SOUTHLAND
DISTRICT COUNCIL

Code of Practice for Subdivision, Land Use, and Development Hearing Agenda

CODE OF PRACTICE FOR SUBDIVISION, LAND USE, AND DEVELOPMENT HEARINGS AND DELIBERATIONS

Figure 5-3 Dimensions of No-Exit Road Turning Areas

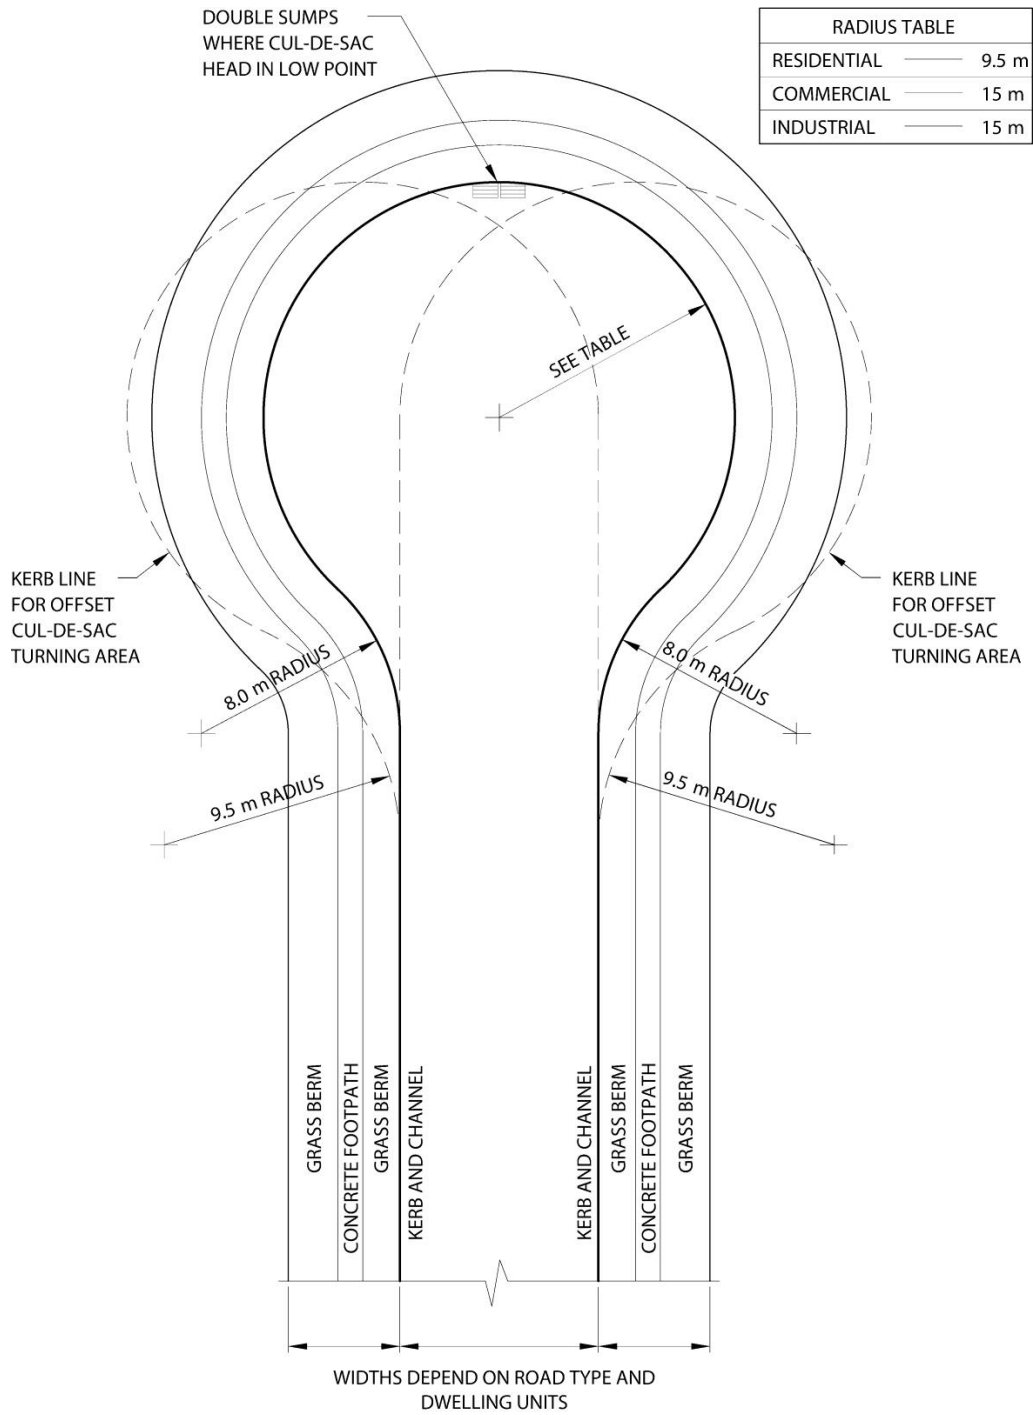
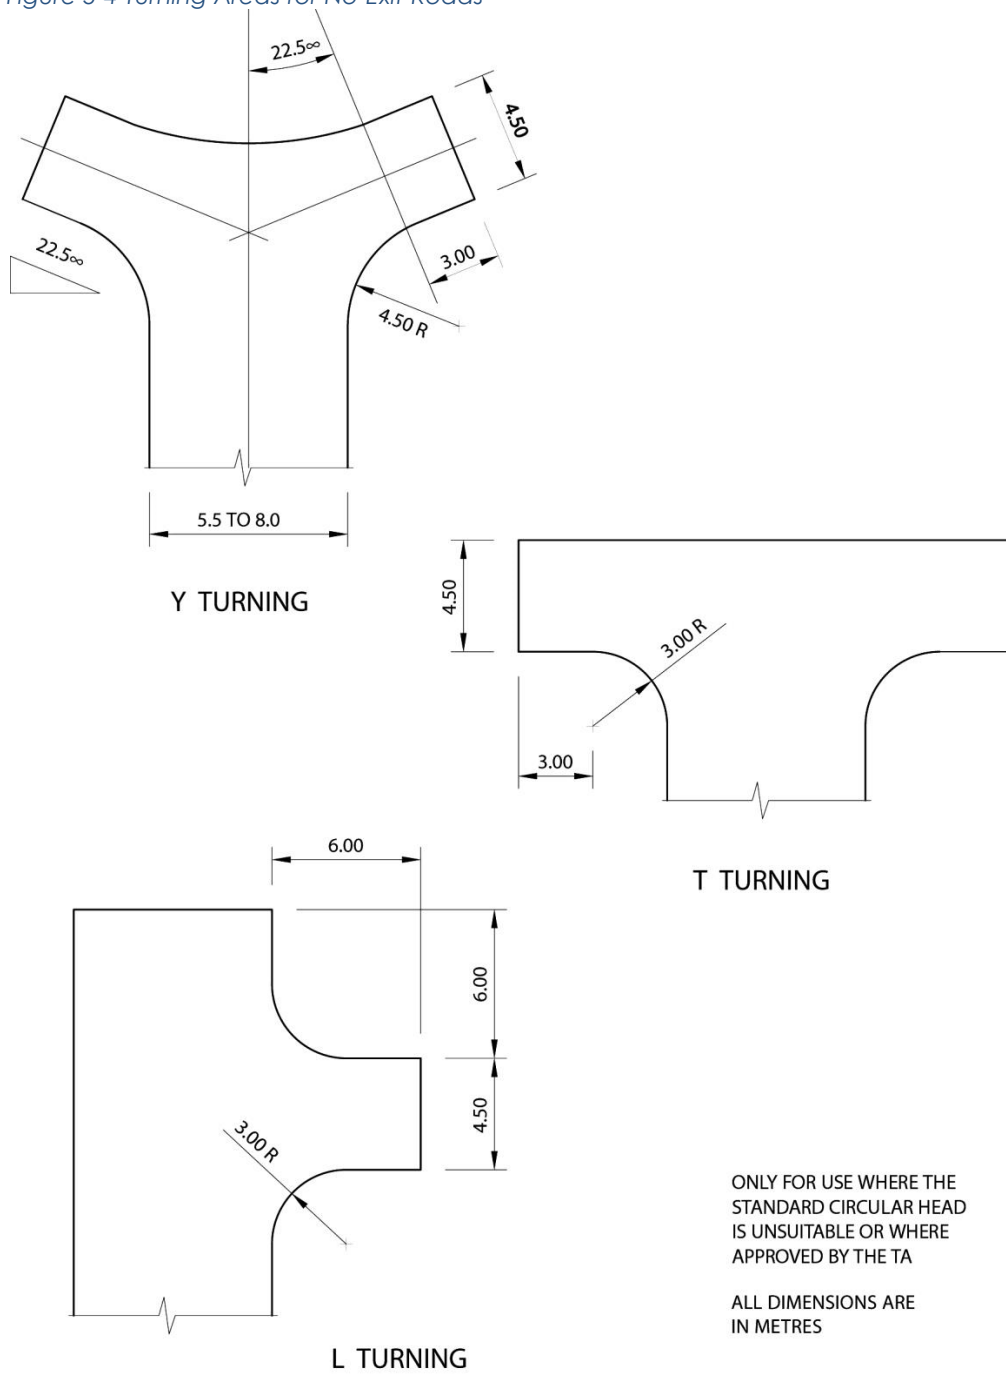
<p>A greater length of transition shall be provided where necessary on non-residential accesses. (b) Not be less than 1 in 250.</p>											
3	<p>Figure 5.3 Dimensions of No-Exit Road Turning Areas</p>	<p>Support in part</p>	<p>Fire and Emergency support in part the dimensions of No-Exit Road turning areas. Figure 5.3 indicates that within Residential Areas the radius of the turning area will be 9.5m. According to “<i>Designers’ guide to firefighting operations Emergency vehicle access, F5-02 GD</i>” fire appliances require that the minimum turning radius of turnaround areas is no less than 11.3m for a pumping vehicle and 12.5m for aerial vehicles As such, 9.5m in the residential area is not considered suitable to enable quick and easy access for fire appliances. A 15m radius in the commercial and industrial areas is suitable for fire appliances. Fire and Emergency therefore request that the dimensions of No-Exit Road Turning Areas in the residential area is amended to 12.5m to enable quick and easy access for fire appliances.</p>	<p>Amend as follows:</p>

It is recommended: no change. The submission is noted, however this is not practical to achieve and will result in extremely large cul-de-sac heads. Retaining a 9.5m radius may result in a fire appliance needing to make a 3-point turn, however this is considered to be an acceptable level of service.

Figure 5-5 Subsoil drains

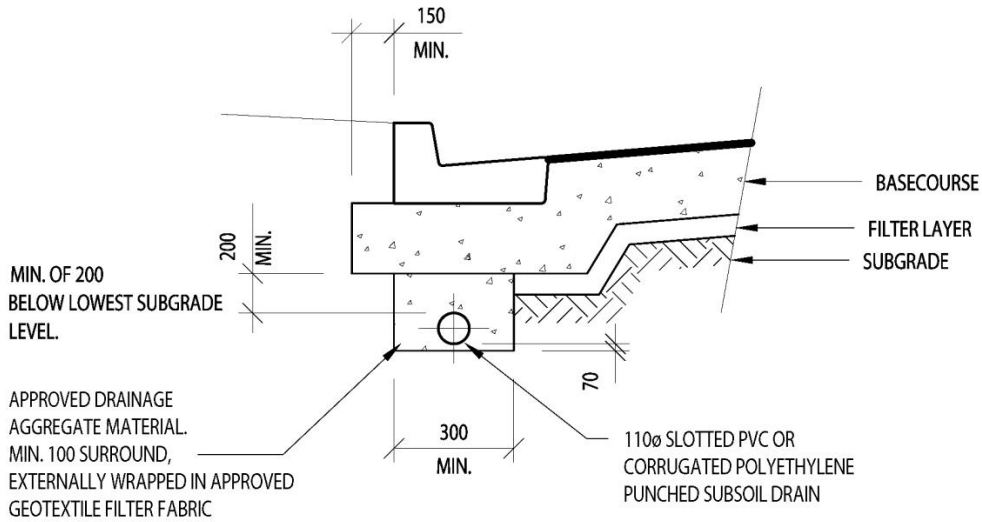
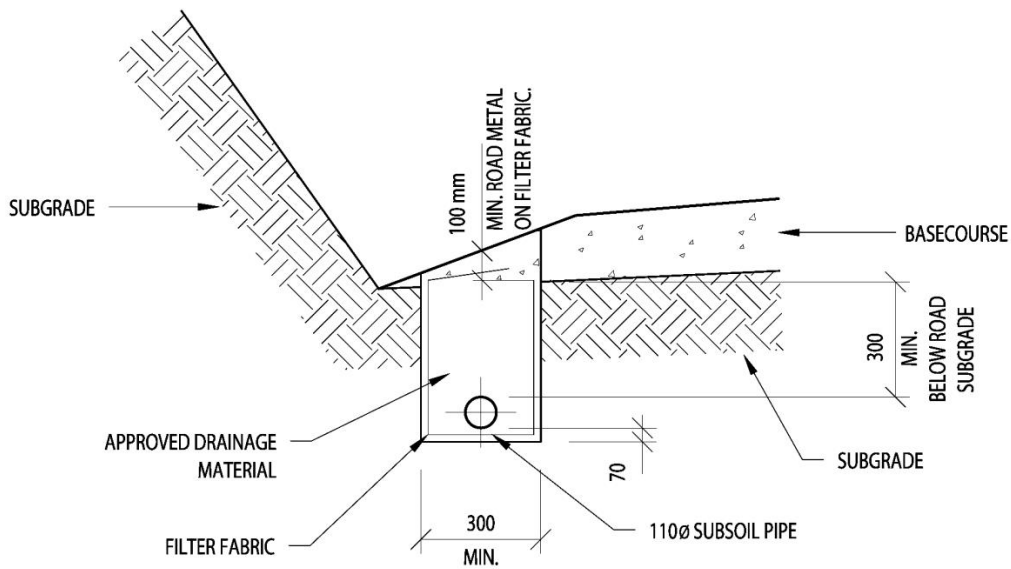
Submitted typical subsoil detail does not meet safety in design and cannot be replaced without removing kerb.

It is recommended: no change. Submission noted but diagram as shown is current as per NZS 4404:2010. This detail will be reviewed at the time of future update of the Code.

Figure 5-10 Accessway sight line requirements

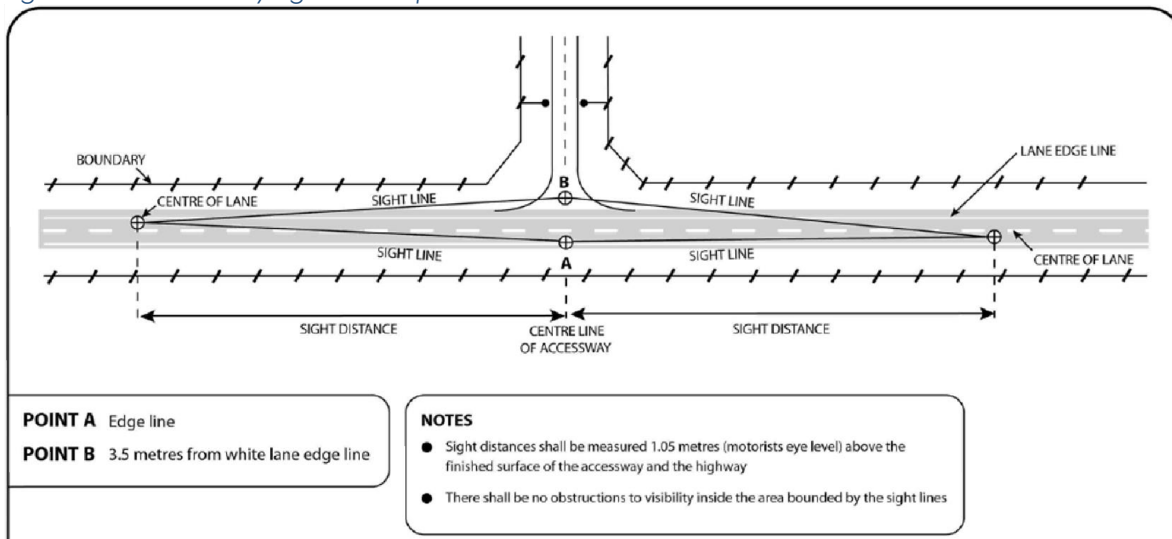
Submitted that the specified minimum sight distances are less than those required in the NZTA Planning Policy Manual, and should be amended to reflect that Manual.

5.5.1	Accessway Sight Lines	96	Waka Kotahi		Section 5.5.1 of the Code of Practice (CoP) addresses 'Accessway Sight Lines'; Figure 5-10 sets out both urban and rural accessways minimum sight line requirements. The minimum sight distances are less than those recommended in Table App5B/1, Appendix 5B of the NZTA 'Planning Policy Manual' (PPM, 2007) for accessways onto the state highway.	Waka Kotahi would like Figure 5-10 amended to require that accessways onto a state highway have minimum sight distances that align with those recommended in the PPM.	Reject the submission. Commentary: The submission is noted, but requires further investigation for adoption in the Code. As worded, the clause is based on Waka Kotahi guidelines document RTS6 (Guideline for Visibility at Vehicle Accesses). Furthermore, Waka Kotahi has ultimate discretion in approving vehicle accesses to State Highway, and the Code would not supersede this discretion. It is considered that this matter can be addressed when the Code is next reviewed.

Section 5.5.1 of the Code of Practice (CoP) addresses 'Accessway Sight Lines'; Figure 5-10 sets out both urban and rural accessways minimum sight line requirements. The minimum sight distances are less than those recommended in Table App5B/1, Appendix 5B of the NZTA 'Planning Policy Manual' (PPM, 2007) for accessways onto a state highway. Waka Kotahi would like Figure 5-10 amended to require that accessways onto a state highway have minimum sight distances that align with those recommended in the PPM. Section 5.3.18.2 of the CoP indicates that culvert pipes shall be a minimum of 300 mm in diameter. Waka Kotahi requires a culvert on a vehicle crossing onto a state highway to have a minimum diameter of 375mm, and we would request that the CoP be amended to align with the NZTA 375mm minimum culvert diameter for crossings onto the highway.
